ASSESSMENT REPORT

DOCKET NO. 72-21

**TOPICAL SAFETY ANALYSIS REPORT
FOR THE CENTRALIZED INTERIM STORAGE
FACILITY**

February 2001

Figure 3-1. Centralized Interim Storage Facility (CISF) site plan (based on Figure 4.1-1 of the CISF Topical Safety Analysis Report)

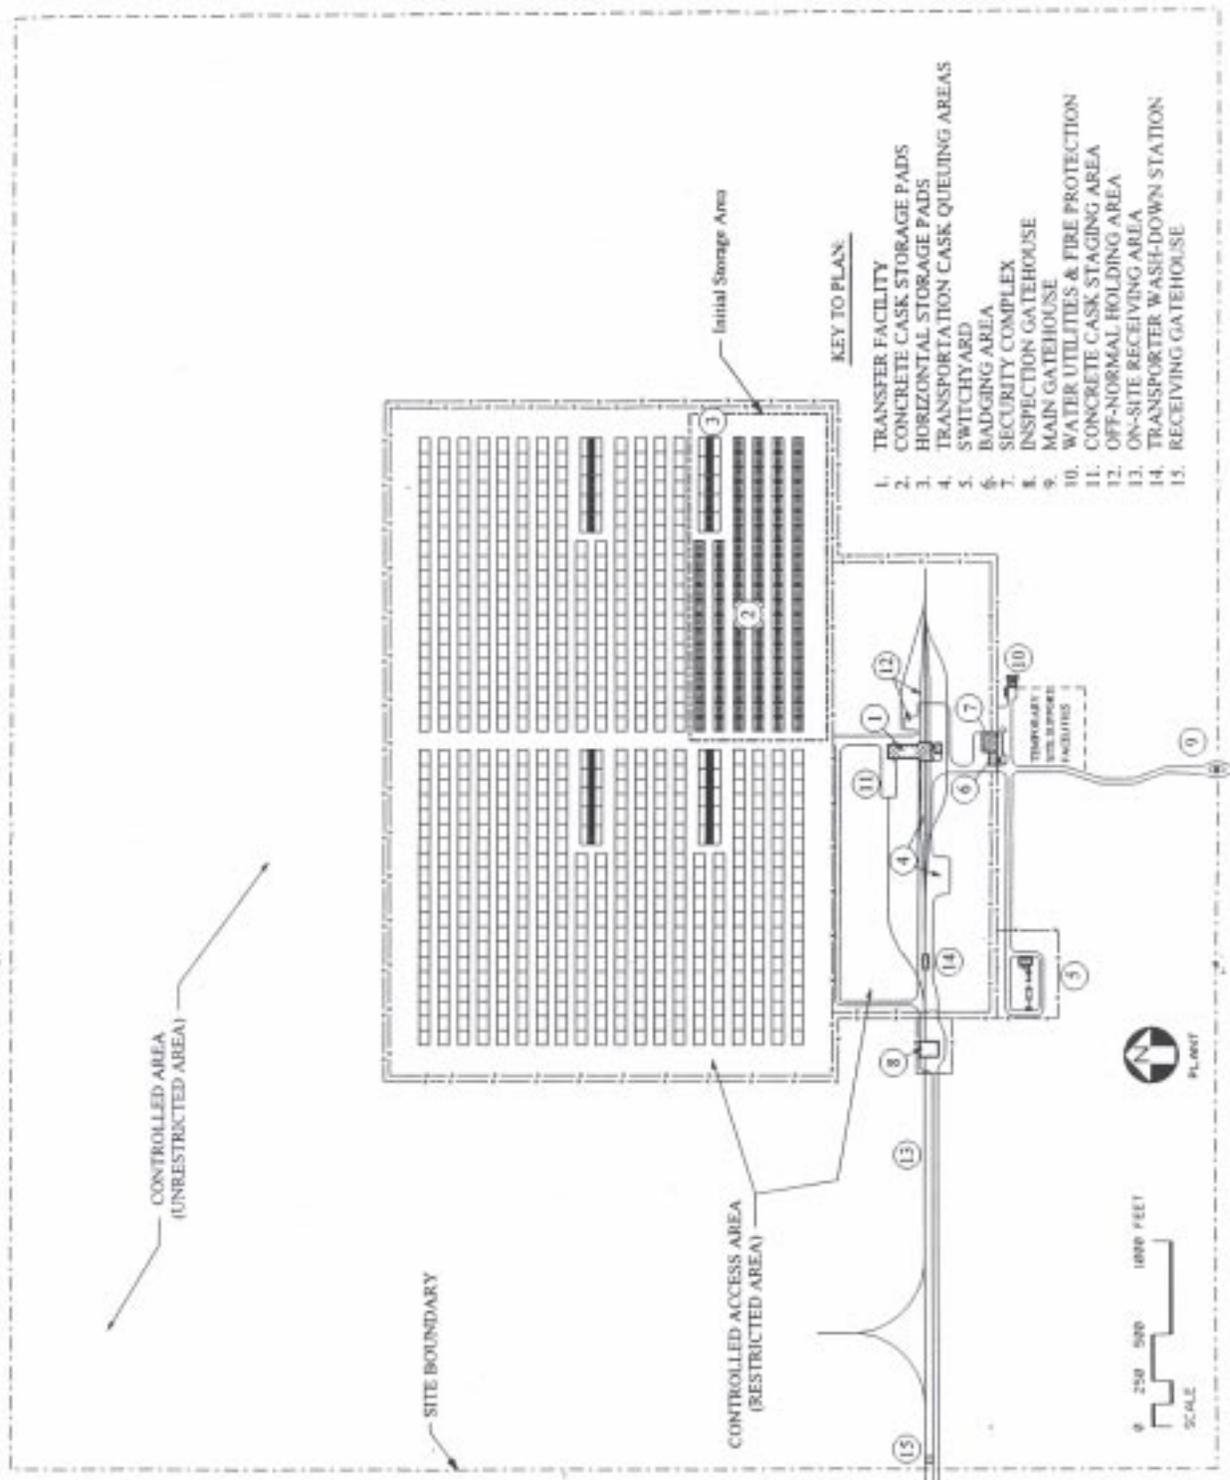
The storage area has been sized to accommodate 40,000 MTU of SNF. A minimum 200-ft buffer will be provided between the unrestricted area and the closest cask storage. A minimum 2,300-ft distance will be provided from the site boundary to the stored fuel. It is not clear, however, if the off-normal holding area meets this criterion (see Figure 3-1). In addition, the storage capacity and design specifications of the off-normal holding area were not provided. The number of individual
